Project	<b>IEEE 802.16 Broadband Wireless Access Working Group</b> < <a href="http://ieee802.org/16">http://ieee802.org/16</a> >	
Title	<b>Proposed Revision of TGm Frame Structure Rapporteur Group Output (C802.16m-08/118r1) regarding Coexistence</b>	
Date Submitted	<b>2008-03-17</b>	
Source(s)	Roger Marks NextWave Wireless Inc.	E-mail: <a href="mailto:rmarks@nextwave.com">rmarks@nextwave.com</a> * <a href="http://standards.ieee.org/faqs/affiliationFAQ.html">http://standards.ieee.org/faqs/affiliationFAQ.html</a> >
Re:	IEEE 802.16m-08/118r1 (“Proposed 802.16m Frame Structure Baseline Content Suitable for Use in the 802.16m SDD”)	
Abstract	This contribution proposes to replace subclause 11.4.5 of IEEE C802.16m-08/118r1. As a result, 802.16 would not be required to sacrifice as much transmission time in the name of coexistence.	
Purpose	To be discussed and adopted by TGm as a modification of subclause 11.4.5 of IEEE C802.16m-08/118r1.

# Proposed Revision of TGM Frame Structure Rapporteur Group Output (C802.16m-08/118r1) regarding Coexistence

Figure 11.4-9a: Alignment of IEEE 802.16m TDD frame with UTRA LCR-TDD frame

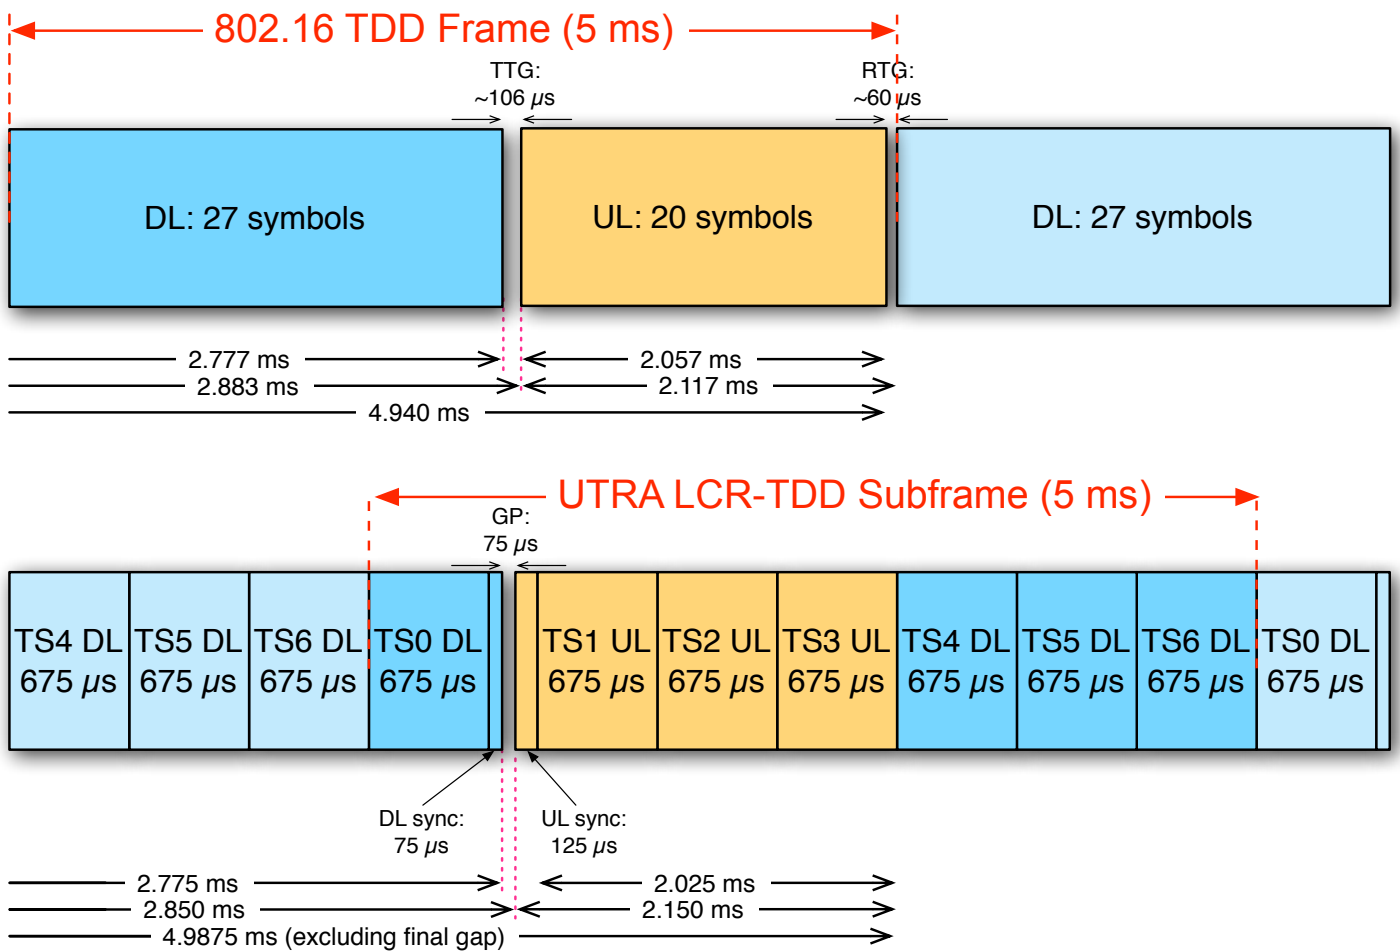
A major drawback of Fig.11.4-9 is that the IEEE 802.16 system is shown to be idle for 333  $\mu$ s around the DL-to-UL switch point and for 205.64  $\mu$ s around the UL-to-DL switch point. This requires the 802.16 system to be idle over 10% of the time simply to address the coexistence issue. This contribution proposes an alternative text and table with much less idle time.

This 10% figure may be an underestimate, because the numbers in Fig.11.4-9 are questionable. In particular, it is not clear how the 333  $\mu$ s at the DL-to-UL switch point was calculated. It is not a multiple of the presumed 102.82  $\mu$ s symbol time, even allowing for extra 64.64  $\mu$ s of idle time allocated per frame in Proposal-1. To emphasize the point, note that the figure shows  $5000 - 333 - 205.64 = 4461.36 \mu$ s of transmission time. This would accommodate  $43.39 \cdot 102.82 \mu$ s symbols – not an integer number of them. It appears that the intent was to drop three symbols and add the extra 64.64  $\mu$ s of idle time. In this case, the idle time at this switch point is  $3 \cdot 102.82 + 64.64 = 373.1 \mu$ s, not 333  $\mu$ s.

Therefore, it appears that Fig.11.4-9 is suggesting 43 symbols per frame, 24 in the DL and 19 in the UL, with a total idle time in 578.74  $\mu$ s. This means that the actual idle time of this proposal seems to be 11.6%.

The inefficiency in Fig.11.4-9 is due to three separate problems:

- (1) Fig.11.4-9 forces 802.16 to idle during the TD-SCDMA DwPTS and UpPTS. These total 200  $\mu$ s. However, there is no obvious coexistence value of forcing the 802.16 system to idle during these periods. DwPTS is a downlink interval for TD-SCDMA, and UpPTS is an uplink interval. The 802.16 system can safely transmit in parallel.
- (2) Fig.11.4-9 requires excess 802.16 idle time at both the beginning and the end of both the 802.16 DL and UL

intervals. If the 802.16 DL is aligned with the start time of the adjacent system's DL, then no idle time need be introduced at the start of the DL. Some mismatch may still occur at the end.

(3) It appears that Fig.11.4-9 is following the subframe concept of Proposal-1, using a rigid grid of six-symbol subframes, each of which can include DL or UL but not both.

Considering these three points, the continuous DL duration in TD-SCDMA (in the 4:3 DL:UL example in Fig. 11.4-9, is  $4*675+75 = 2775 \mu\text{s}$ . To calculate the number of 802.16 symbols that will fit, we need to know the symbol period. If we take, for example, the symbol duration of  $102.82 \mu\text{s}$ , we can fit 27 DL symbols. [This would extend  $1 \mu\text{s}$  into the  $75 \mu\text{s}$  TD-SCDMA gap.] Likewise, the TD-SCDMA UL time, including the  $75 \mu\text{s}$  gap reserved in TD-SCDMA for the DL-to-UL switch, is  $3*675+125+75 = 2225 \mu\text{s}$ , long enough to hold 20 symbols of  $102.82 \mu\text{s}$ , with  $168.6 \mu\text{s}$  left over for gap time.

By this analysis, coexistence with TD-SCDMA can be achieved while using 47 symbols of  $102.82 \mu\text{s}$  each, which keeps the 802.16 system busy for 4832.54 out to 5000  $\mu\text{s}$ . The idle ratio is 3.3%.

The bottom line here is that Fig.11.4-9 allows 24 DL symbols and 19 UL symbols per frame. Correcting the three problems allows 27 DL symbols and 20 UL symbols per frame. This increases the throughput by 9.3% compared to Fig.11.4-9.

Coexistence between IEEE 802.16m TDD and UTRA LCR-TDD (TD-SCDMA) may be facilitated by synchronizing and aligning the IEEE 802.16m and UTRA LCR-TDD frames. This is illustrated in Figure 11.4-9a for a special case: the legacy 802.16 TDD frame with 27:20 DL:UL symbol ratio and TD-SCDMA 4:3 DL:UL symbol ratio. This concept can be generalized to other DL:UL ratios. Note that the TTG shown here is that of the legacy system. It could be adjusted in 802.16m if, for instance, the TTG was chosen to be one symbol duration. This would not affect the concept.

Using Fig. 11.4-9a, 802.16 would not, in this example, be required to sacrifice transmission time in the name of coexistence. However, this requires that the DL and UL be permitted to begin at arbitrary times, or with a granularity of one symbol. If 802.16m adopts a rigid allocation regime in which subframes can begin only on multiple of a fixed resource allocation unit, additional inefficiencies may result.

**Figure 11.4-9b: Alignment of IEEE 802.16m TDD frame with UTRA LCR-TDD frame, assuming a rigid subframe of six symbols, 102.82  $\mu$ s each**

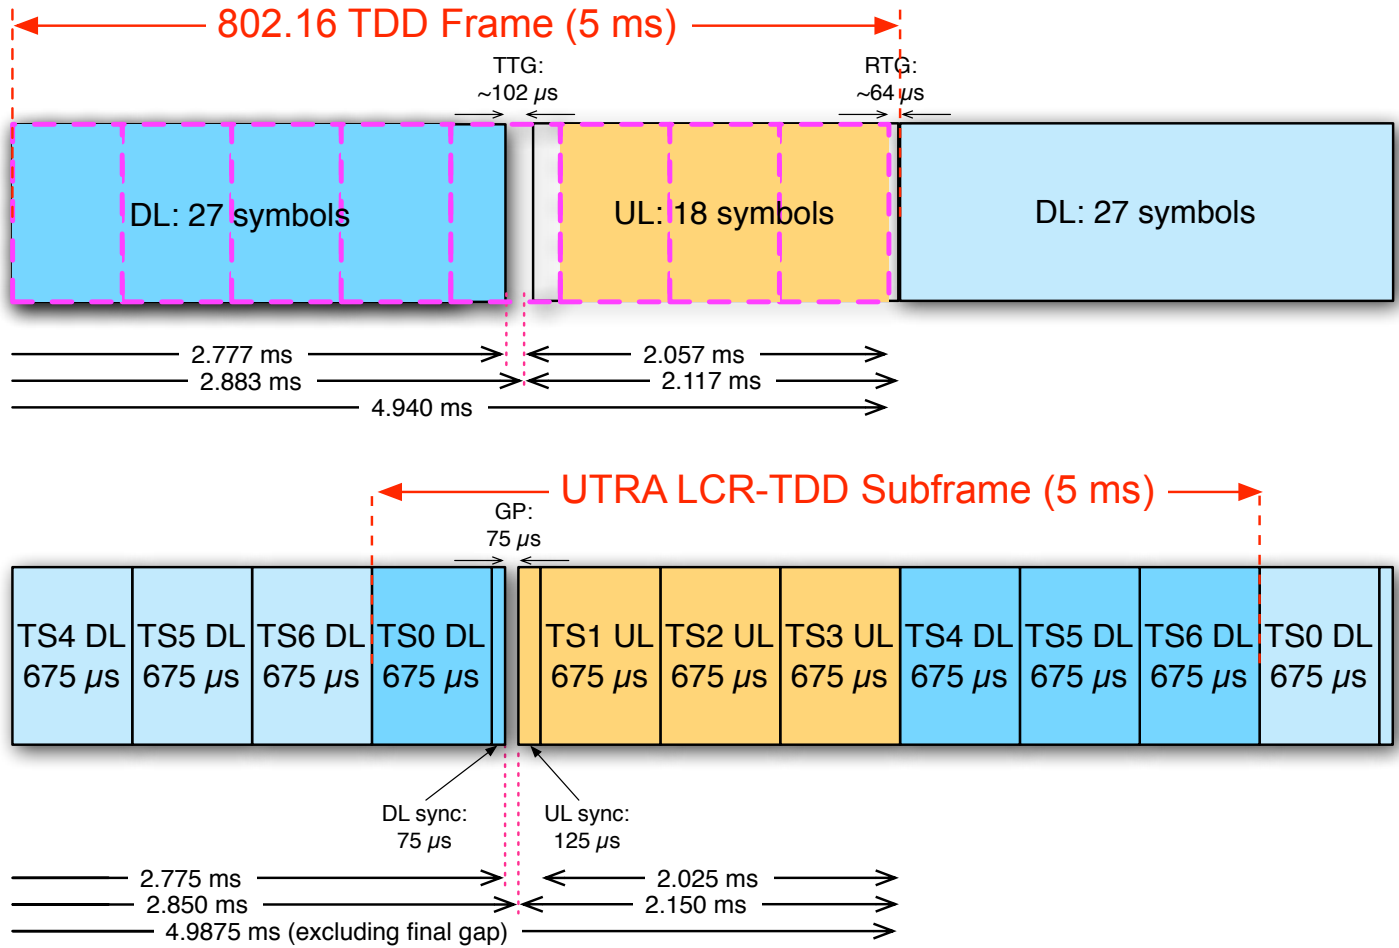
While the correction of (1) and (2) is straightforward, the correction of (3) would require a more flexible subframing structure. Since that is not a given, we could consider a coexistence solution that corrects for (1) and (2) but not (3), assuming the rigid six-symbol subframe. As shown in the figure below, this would recover two of the four symbols wasted in the method of Fig.11.4-9. The DL would include 27 symbols, but the UL would include only 18; two UL symbols would be lost to the subframe roundoff.

Figure 11.4-9b illustrates the same coexistence scenario using a rigid subframe of six symbols, each of 102.82  $\mu$ s duration.
